ITEM 4. DEVELOPMENT APPLICATION: 251-253 ELIZABETH STREET AND 238-240 CASTLEREAGH STREET, SYDNEY (HELLENIC CLUB & AUSTRALIAN WORKERS UNION (AWU) BUILDING)

FILE NO: D2003/00781

DATE: 7/12/04

Proposal: Stage 1 development application for a proposed 18 storey mixed use (commercial / club / retail) building envelope with a maximum height of 66m above Elizabeth Street (RL93.08m), and Floor Space Ratio of 13.42 : 1 (including the equivalent of 0.92 : 1 of Floor Space in the basement, which is proposed to be excluded), including: -

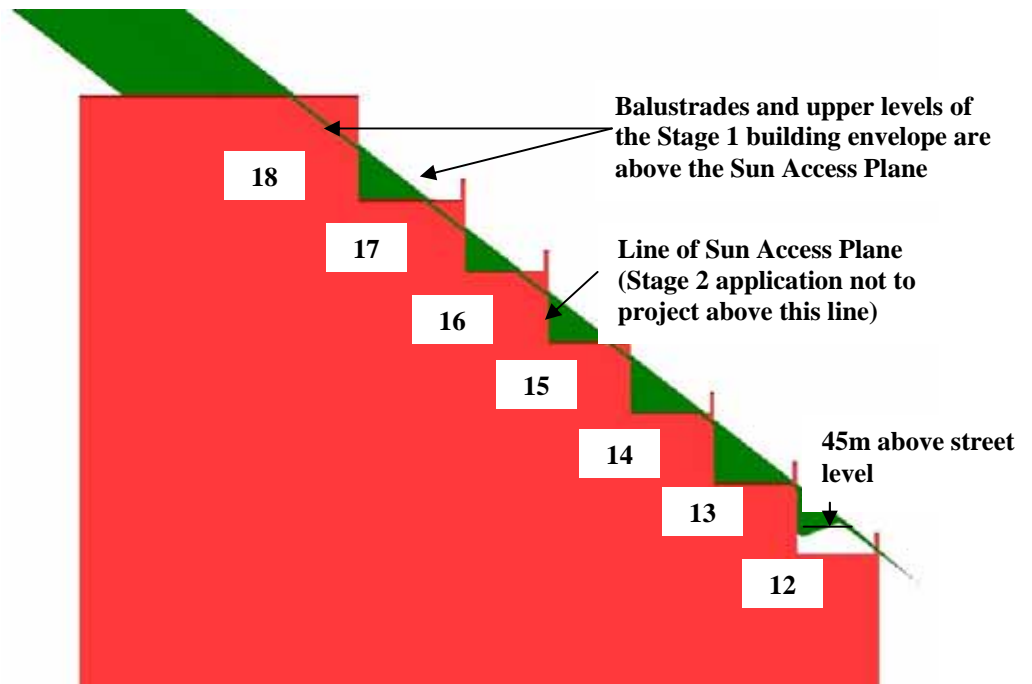
35. The proposed Stage 1 envelope has been found to exhibit minor non-compliances in terms of this control, due to the fact that small portions of the eastern elevation project above the Hyde Park West Sun Access Plane. However, as the extent of non-compliance is minor, it is considered appropriate to recommend a condition for the development to comply with this control at Stage 2.

37. For reasons of clarity, the extent of non-compliance is indicated in the diagrams below.

Indicative section of the proposed building envelope, illustrating that the proposed balconies, and upper levels of the building are required to be modified so that no part of the building projects above the Sun Access Plane for Hyde Park West

- (2) The building envelope is only approved on the basis that it be amended to comply with the Sun Access Plane for Hyde Park West, and the Central Sydney DCP 1996 in respect of Clauses 2.3 (side setbacks), and that the ultimate building design will be wholly contained within the envelope and provide an appropriate relationship with neighbouring buildings. In addition, the setback of the proposed tower from the façade of the AWU Building shall match the setback of the adjoining building to the north.

Note: All parts of the building must comply with the Hyde Park West Sun Access Plane. A report prepared by a registered surveyor must be submitted with the Stage 2 application, which certifies that the development complies with the Hyde Park West Sun Access Plane.
